ISSUE 25 - APR-MAY-JUN 89

SECTION 1 - INFO

SECTION 3 - AMIGA

25/3-3.1 A2000 GURU MESSAGE ON POWER UP W/ REV 6 PCB.

DIAGRAM 25/3-3.2

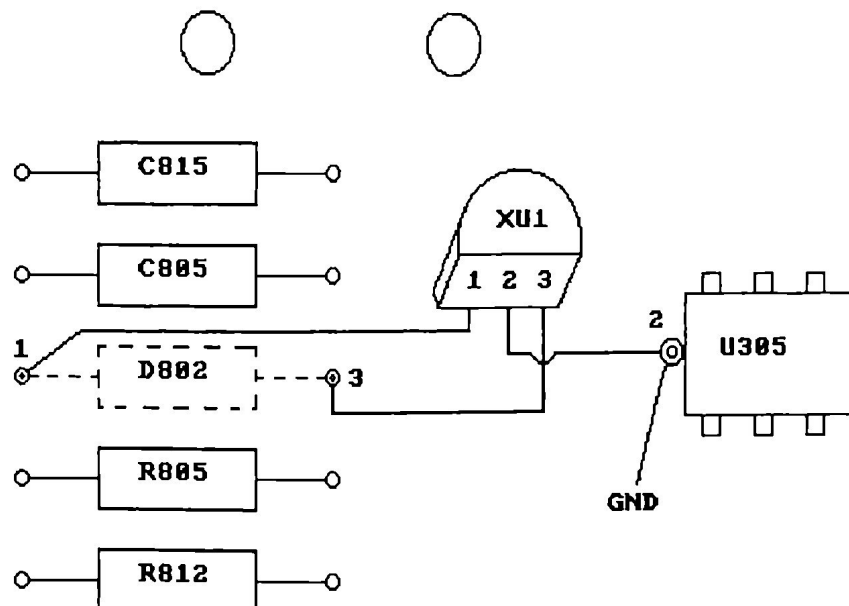
NEW DRAMS MAY RETAIN DATA FOR AS LONG AS FIVE (5) MINUTES AFTER POWER OFF. AN ADVISORY MESSAGE ON POWER UP MAY INDICATE THAT THE ERROR MESSAGE GENERATED BY POWER OFF HAS BEEN RETAINED. PRESSING THE LEFT MOUSE BUTTON WILL ALLOW THE SYSTEM TO RESUME A NORMAL START UP.

A MITSUMI PST518B, RESET IC (CBM PN# 328156-02) SHOULD BE INSTALLED AS FOLLOWS:

LOCATE U305 (TO THE LEFT OF CN303, 34 PIN DRIVE CABLE).
LOCATE D802 (DOWN, TO THE RIGHT OF U305).
INSTALL PST518B (DESIGNATED XU1) USING INSULATION TUBING AS REQUIRED TO PREVENT THE POSSIBILITY OF SHORTS.

SOLDER PIN 1 OF XU1 TO +5 VOLT SIDE OF DIODE D802.
SOLDER PIN 2 OF XU1 TO GND, USE PLATED HOLE AT THE BASE OF IC U305.
SOLDER PIN 3 OF XU1 TO THE ANODE SIDE OF DIODE D802.

THIS FIX SHOULD BE DONE IF REQUESTED BY THE CUSTOMER,
AND WILL BE COVERED, AS A COMPONENT LEVEL REPAIR,
UNDER WARRANTY.
